UNITED STATES PATENT AND TRADEMARK OFFICE

APPLICATION NO.	FILING DATE	FIRST NAMED INVENTOR	ATTORNEY DOCKET NO.	CONFIRMATION NO.
10/651,228	08/29/2003	Daniel D. Evans	0316	8913

Office Action Summary	Application No.	Applicant(s)	
	10/651,228	EVANS, DANIEL D.	
	Examiner	Art Unit	
	Katherine W. Mitchell	3677

DETAILED ACTION

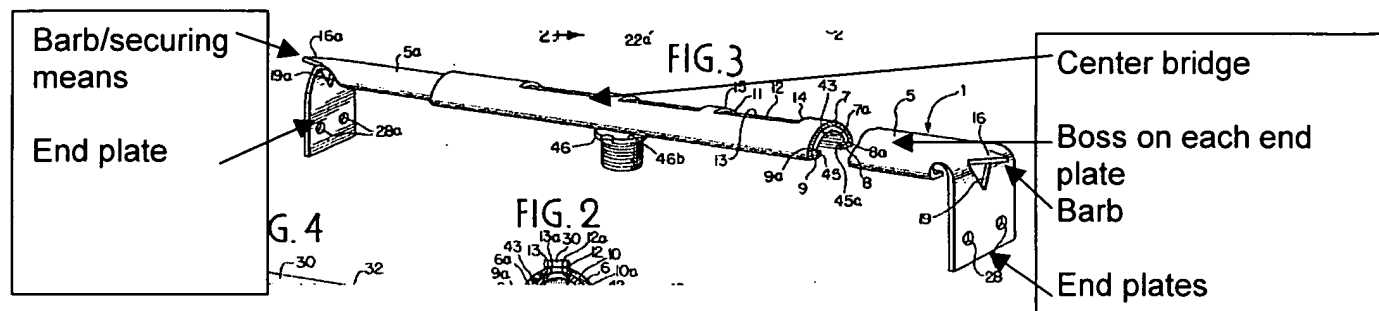
4. Claims 1-6, 8-12, 34-38 are rejected under 35 U.S.C. 102(b) as being anticipated by Cogdill, USP 3518421.

Re claims 1, 34, Cogdill teaches an apparatus capable of holding conduits in a trench having a bottom and a pair of sides, comprising in combination:

a center bridge portion capable of being disposed against the conduits in the trench;

a pair of end plates secured to the center bridge and capable of being disposed against the trench sides, and

a boss on each end plate extending outwardly from the endplate for receiving the bridge.

Re claim 2 and further re claim 34: "16", "16a" is the securing means /barb.

Re claims 3-4 and 37: The barb/securing means 16 extends upwardly and outwardly from the end plate, as shown in Fig 3 above.

Re claim 5 and 38: Since the barbs are planar, they are considered in the configuration of louvers.

Re claim 6: Barbs 16 and 16a are generally parallel to each other.

Re claims 8-9 and 35: The end plates are rectangular, and include apertures 28.

Fig. 1a
 (PRIOR ART)

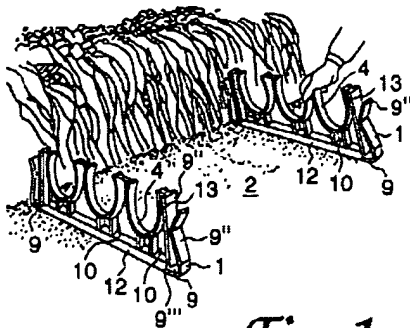
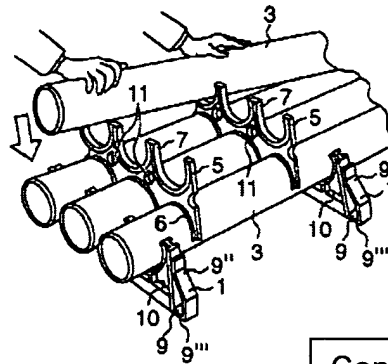
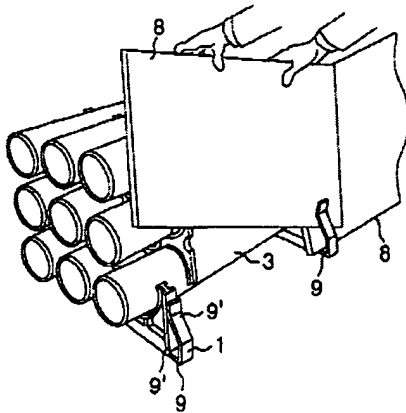
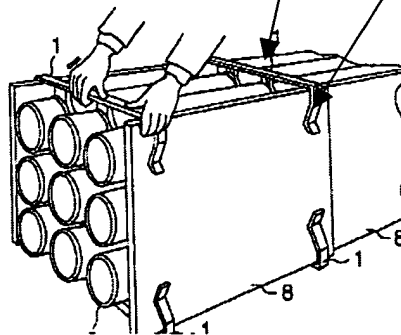
As discussed above, Cogdill teaches all the elements except the use of the apparatus with a trench having non-cohesive soil. Examiner notes that applicant is not claiming merely the intended use, but is positively requiring a trench with non-cohesive soil. Non-cohesive soil is shown in Figs 1a and as taught in col 2 below:

FIGS. 1a-1d show the assembling of a casting mould in accordance with the previously known technique. Concrete is to be poured into the casting mould in order thereby to
45 form a pipe assembly, preferably for cables. As can be seen from FIG. 1a, base parts 1 included in the casting mould and preferably made of plastic material are first placed at a distance from one another on the ground which has already been levelled, most often on the bottom 2 of a pit or a trench.
50 A first row of plates 3 is then arranged into place in manner

Fig. 5

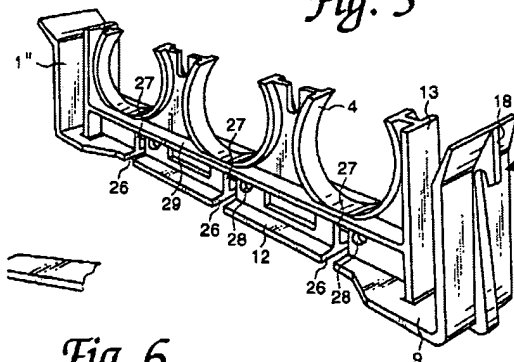
Center bridge
 End plates
